**Re: Initial Submission Review: Green Valley Ranch East – Tibet Road Preliminary Plat - Minor Amendment 2**

**Case Number: 2021-6018-02**

# N. TIBET ROAD - TRIBUTARY T TO 48TH AVENUE INFRASTRUCTURE SITE PLAN

| Sheet Number:   | 2        |

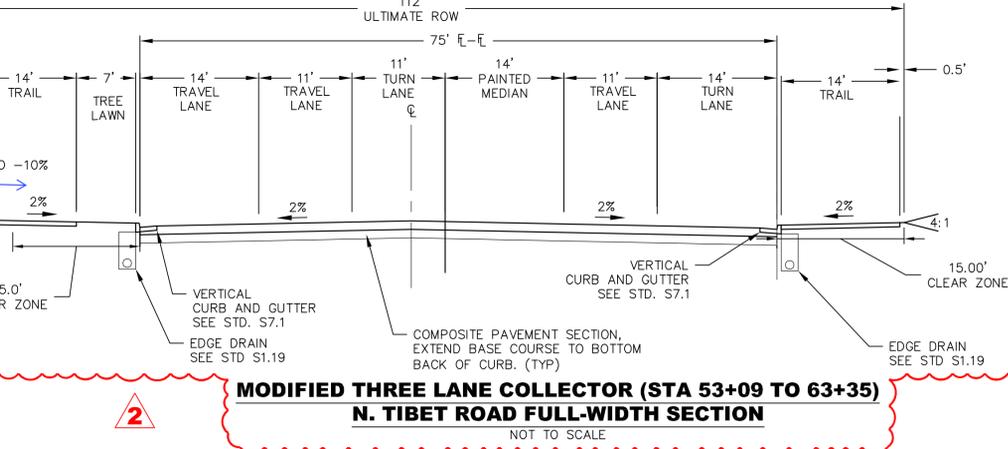
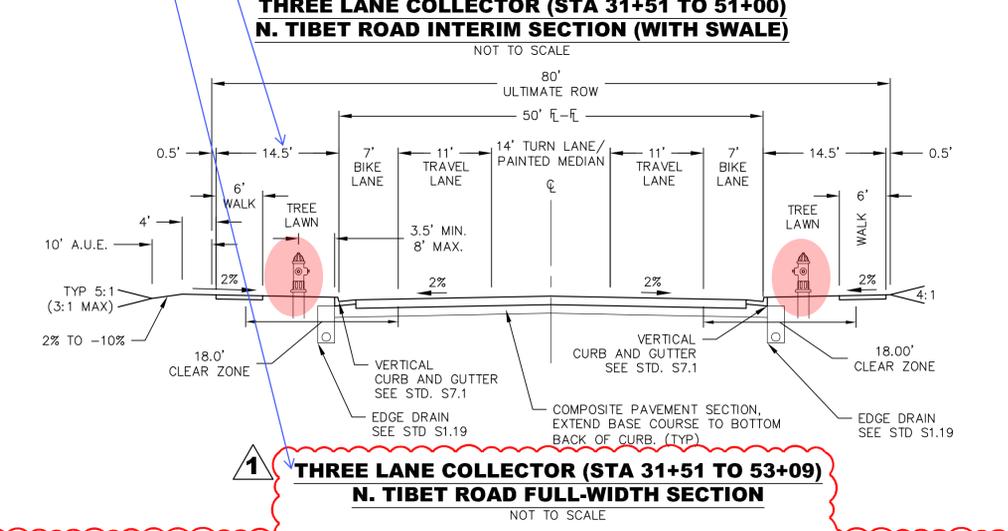
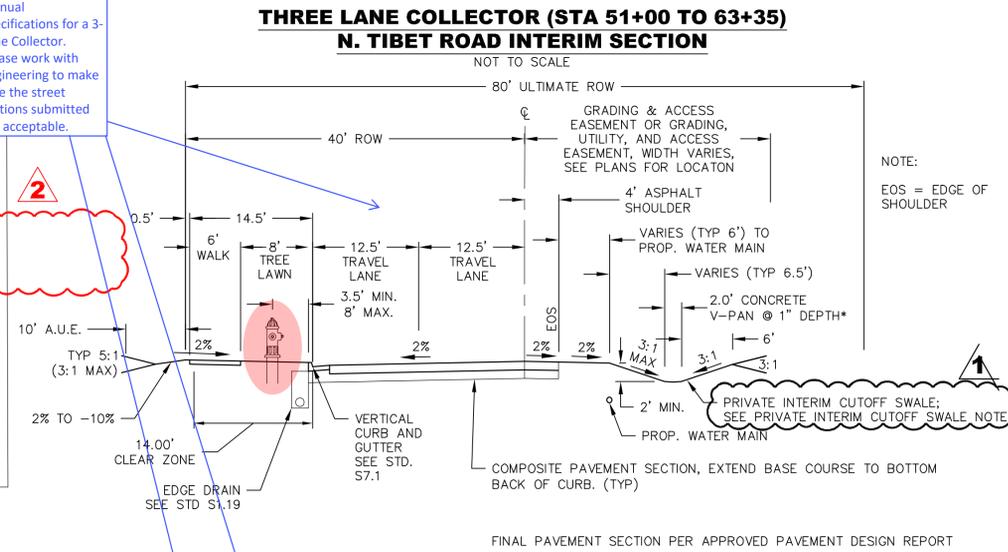
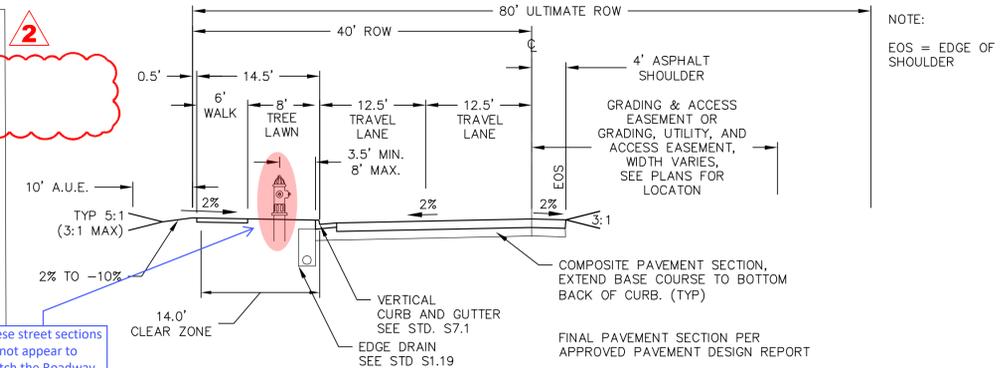
Please show the Fire Hydrants in all street section details.  
 Hydrants and dimensions have now been provided.

This sheet does not match Amendment 1

Layout of sheet was modified to fit an additional section view. No other changes were made to the existing sections on this sheet other than those reclassified.

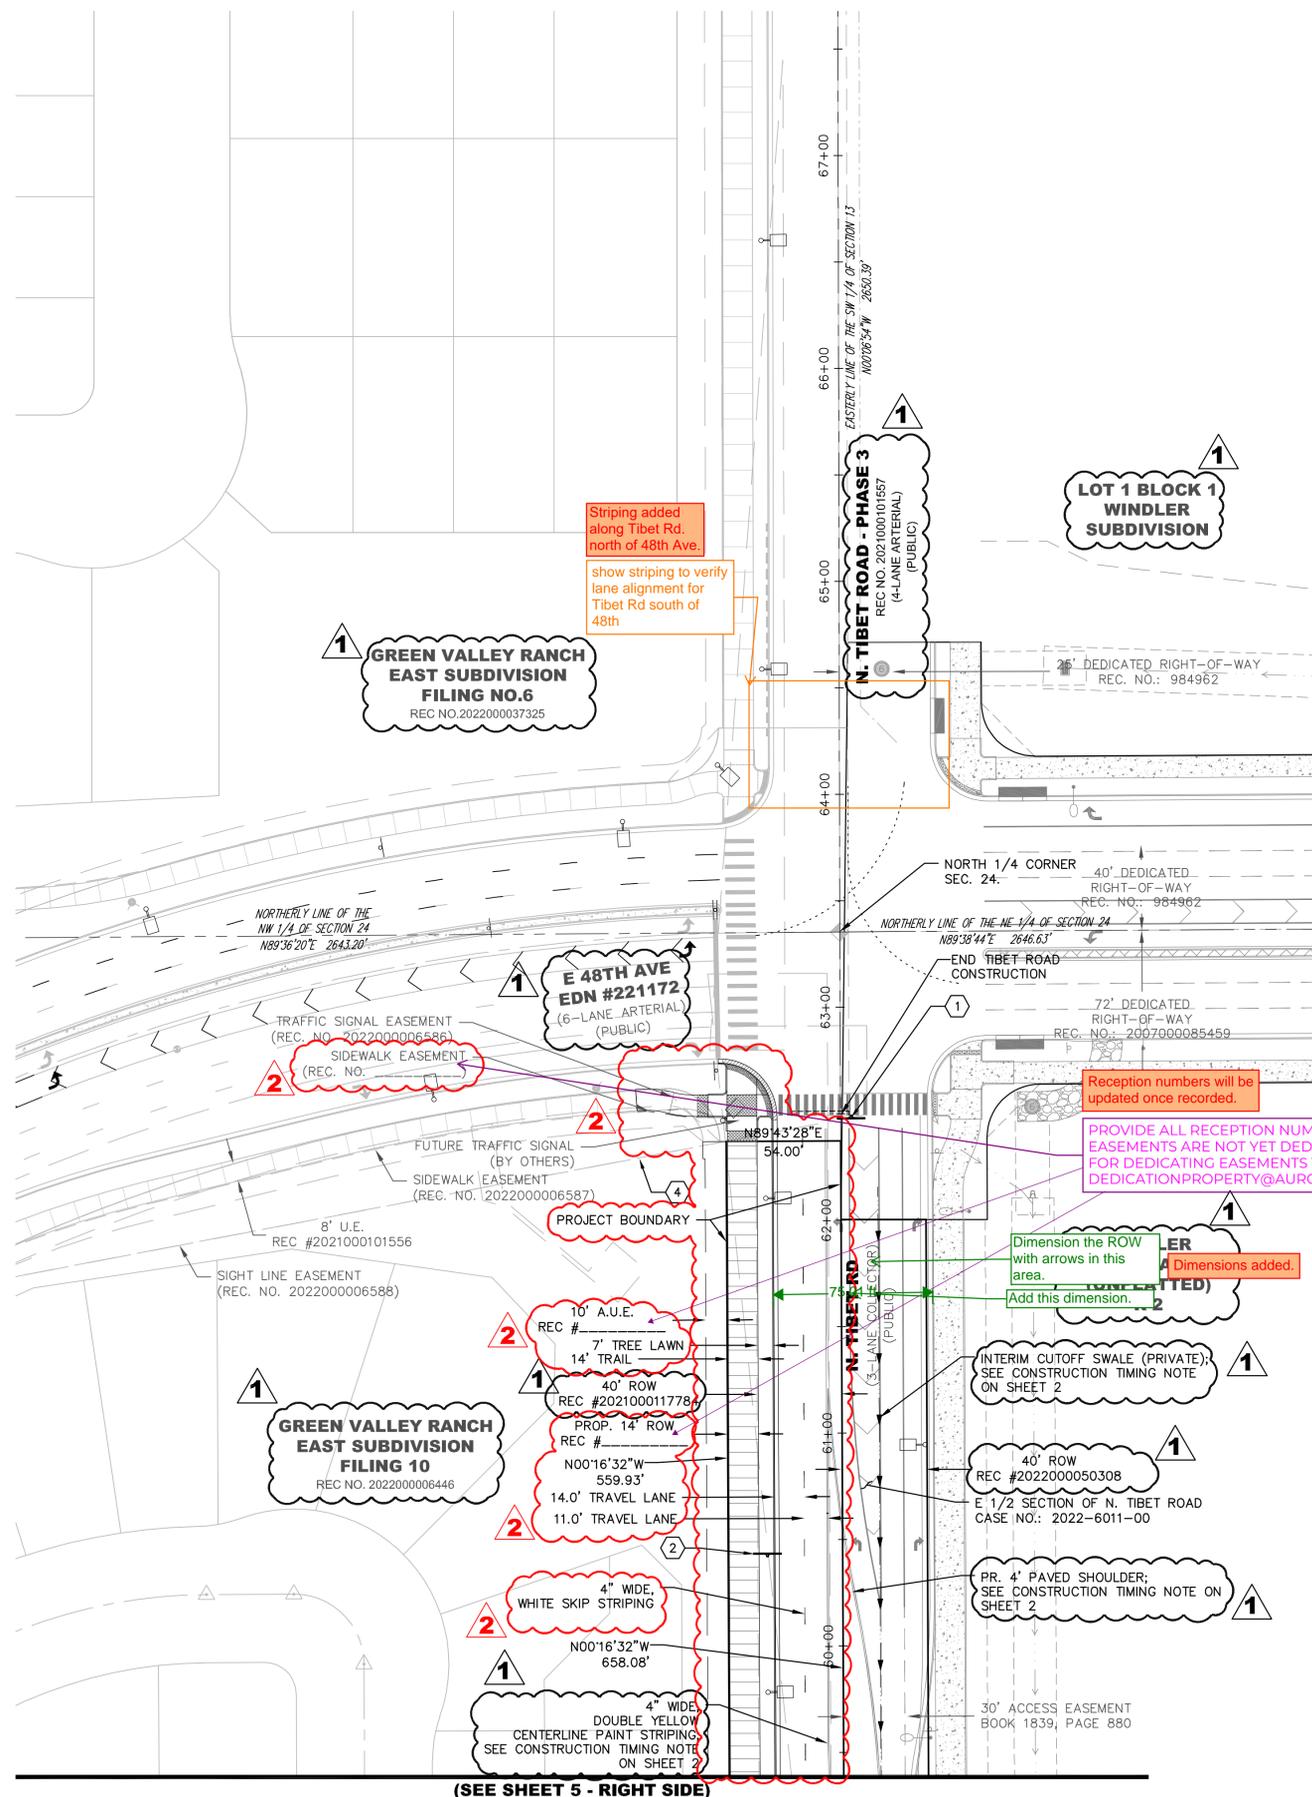
add pavement arrows and lane drop signage  
verify lane drop taper is WS/60  
Pavement arrows and lane drop signage has been added.  
Lane Drop Taper = WS/60 = 12\*(35)/60 = 245'

Dashed striping removed.  
remove dashed striping

was the crusher fines bike path and note removed with this amendment? if so, expand the cloud around the area where the note was deleted.  
Temp crusher fines bike path and notes have been removed from the plans with this amendment due to updated construction timing. Sheets 4&8 have been added back into the set and crusher fines trail removals have been reloaded on all sheets as necessary.

Striping added along Tibet Rd. north of 48th Ave. show striping to verify lane alignment for Tibet Rd south of 48th

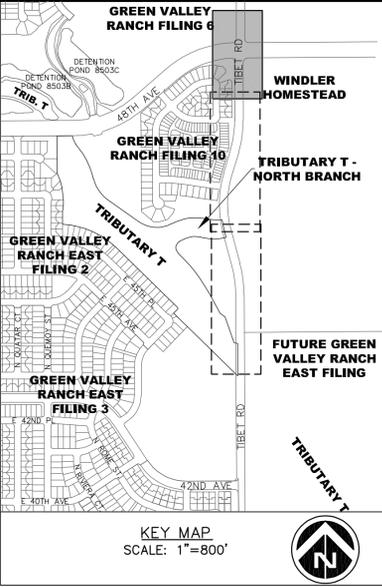
Dimension the ROW with arrows in this area. Add this dimension.

- 3A. Dimension the right-of-way with arrows in the area noted on Sheet 5. Add the dimension noted, as well. **RESPONSE: Dimensions added.**

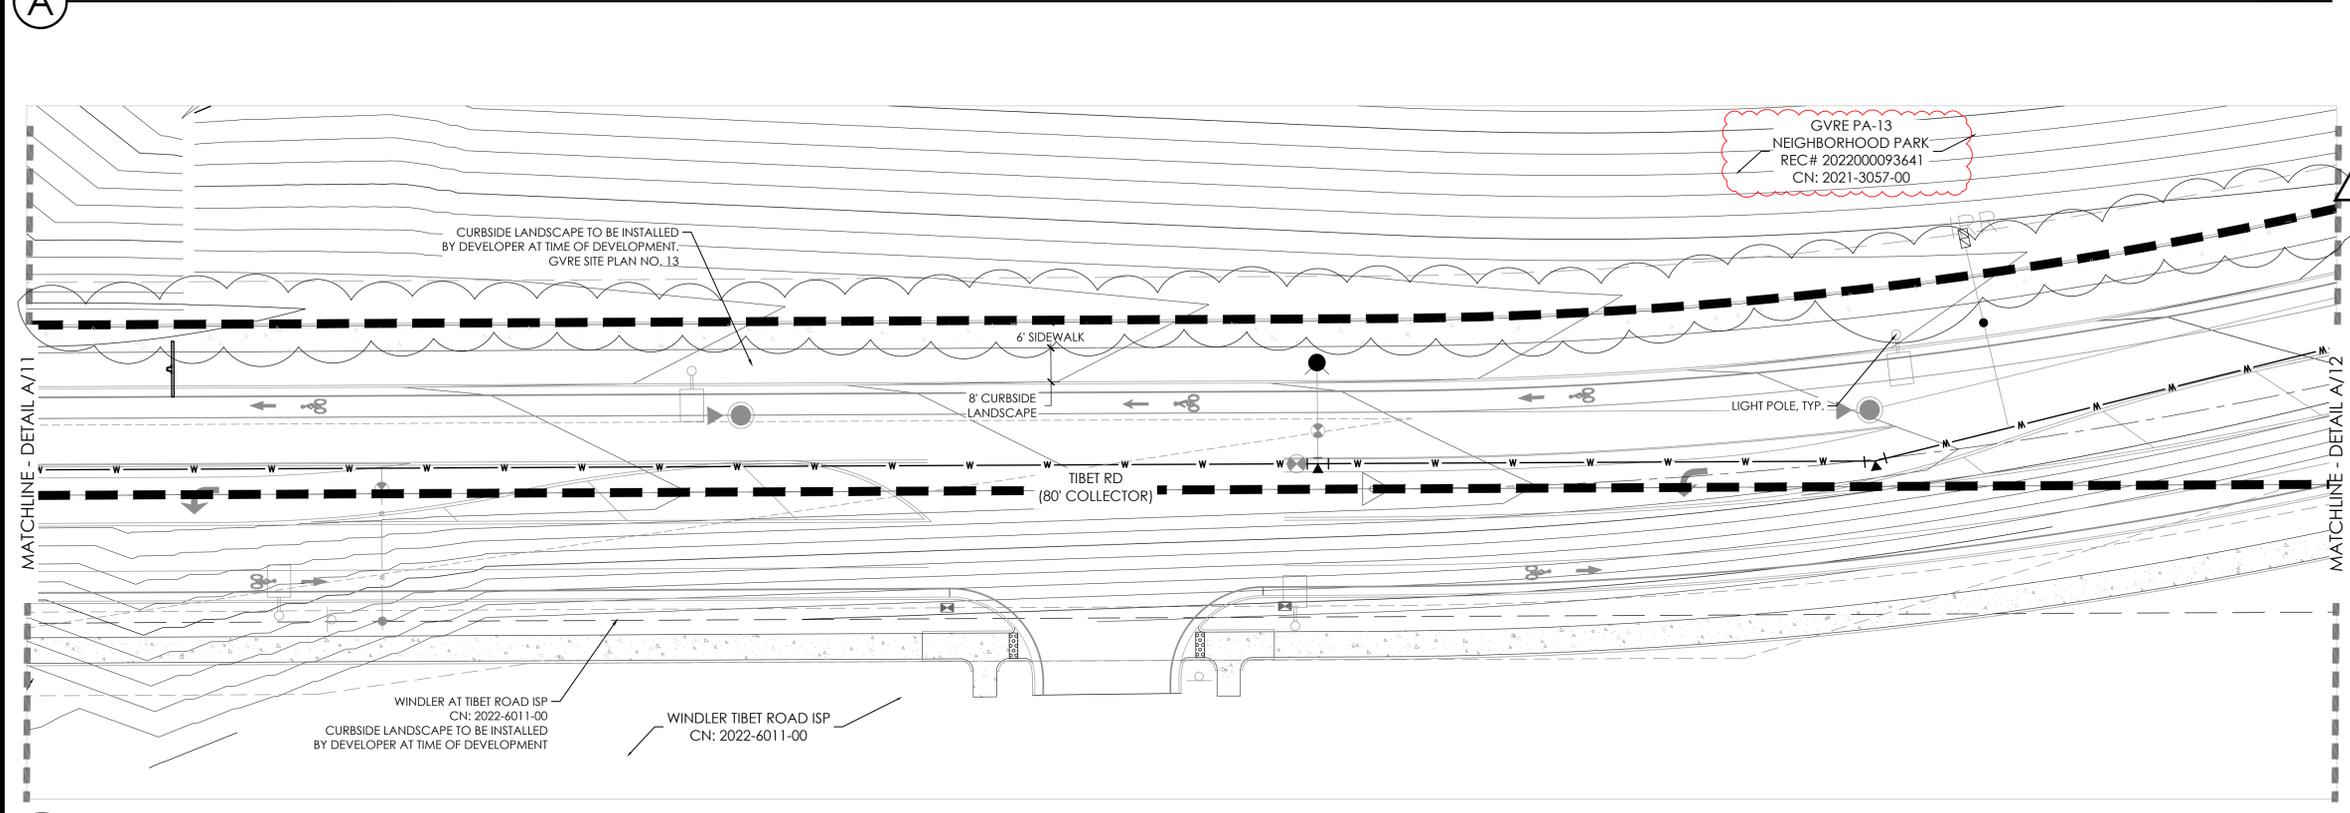
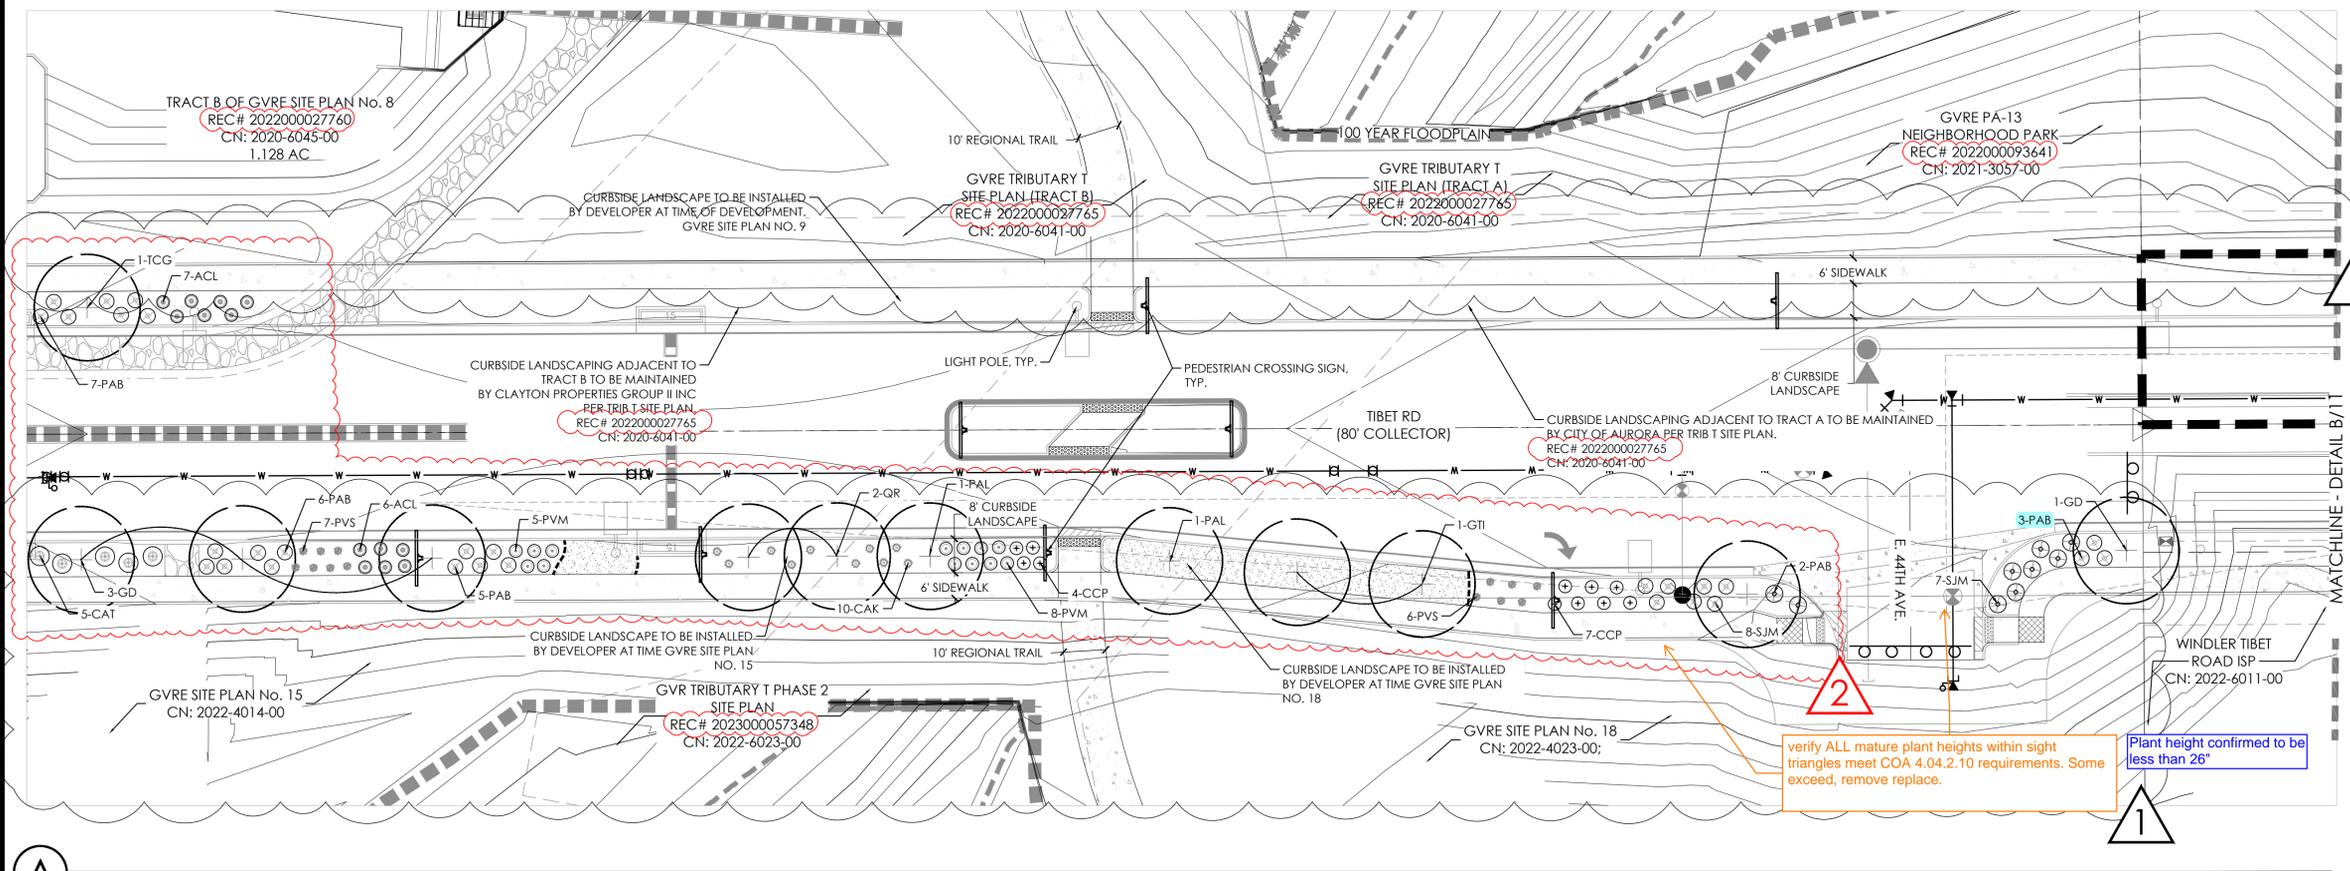
interim swale note removed? If so, cloud the whole thing and put a delete box over it for Amendment 2.

Swale note has been added back since swale is still in place.

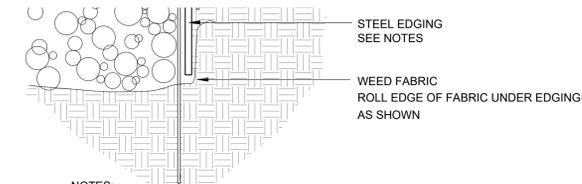
can't find this plant. Comes up as Tridens stricta 'Buffalo Feathers' and can be up to 7' tall

- 2A. A search for Buffalo Feathers Russian Sage leads to Tridens stricts 'Buffalo Feathers' (not Perovskia). This variety can grow up to 7' tall. Replace this plant type or provide more information to show it doesn't exceed the maximum height within the sight triangle. **RESPONSE: Planting revised.**
